**Before the
FEDERAL COMMUNICATIONS COMMISSION
Washington, DC 20554**

In the Matter of)
)
AUDACY CORPORATION)
)
Application for Authority)
to Launch and Operate a) File No. SAT-LOA-20161115-00117
Non-Geostationary Medium)
Earth Orbit Satellite System)
in the Fixed- and Inter-Satellite Services)

REPLY OF ELEFANTE GROUP, INC.

Relay ↔ Base Users Service Area

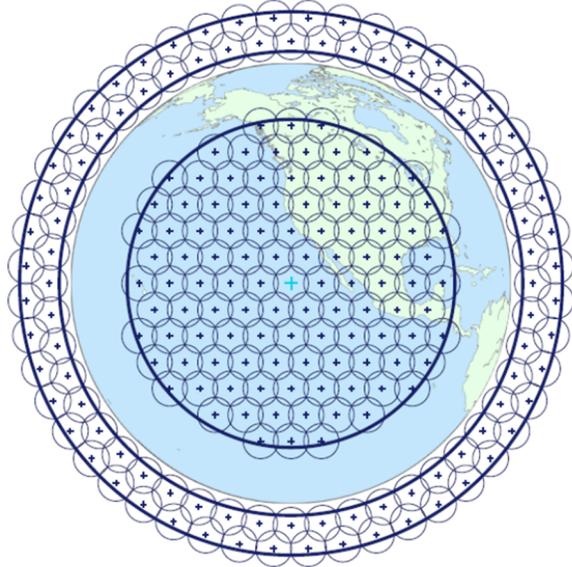
than the rule.”¹⁷ A majority (109 of 205) of the Base Service beams illustrated in Figure III-3 of the Narrative Statement (reprinted below) are directed at the Earth.¹⁸

Elefante Group acknowledges that, with the edge of the Earth facing pattern at approximately 25 degrees elevation relative to the Audacy Relay satellites, the majority of the < 1500 km altitude coverage volume nonetheless is served by the 96 beams directed above the Earth’s limb. Despite this, Audacy’s contentions in the Opposition appear to be a material departure from the Application. The Narrative Statement, Section III-H, describes “hundreds of Users within [Each Relay’s] service area,”¹⁹ implying that the number of Base User satellites in the coverage volume uniquely served by the Earth-intersecting beams will not be inconsequential, especially given the large area of the Earth’s surface covered by each such beam.

In any event, Audacy's *qualitative* effort at rebuttal cannot be evaluated meaningfully because it is not accompanied by a clear *quantitative* assessment of the percentage of the time that Audacy will transmit above the earth's surface relative to the frequency Base User signals will be directed toward the earth. Audacy makes no commitments in this regard as to how it will operate its network. This information and data about its operations, which Audacy has not satisfactorily provided, is essential to substantiate and better understand Audacy's claims and to assess the potential for compatibility with other operators, including those developing and deploying new and emerging terrestrial applications of the spectrum, such as Elefante Group.²⁰ The potential severity of interference into these terrestrial applications will be a product of frequency overlap, geometric alignment, and the duty cycle of channels in the Audacy system's beams. Any interference analysis must take all of these into account to assess magnitude and statistical significance. The Commission should require Audacy to supplement its filings to provide this data and related quantitative assessment to ensure a proper evaluation of the potential compatibility of its proposal with other uses of the spectrum can be undertaken by interested parties.
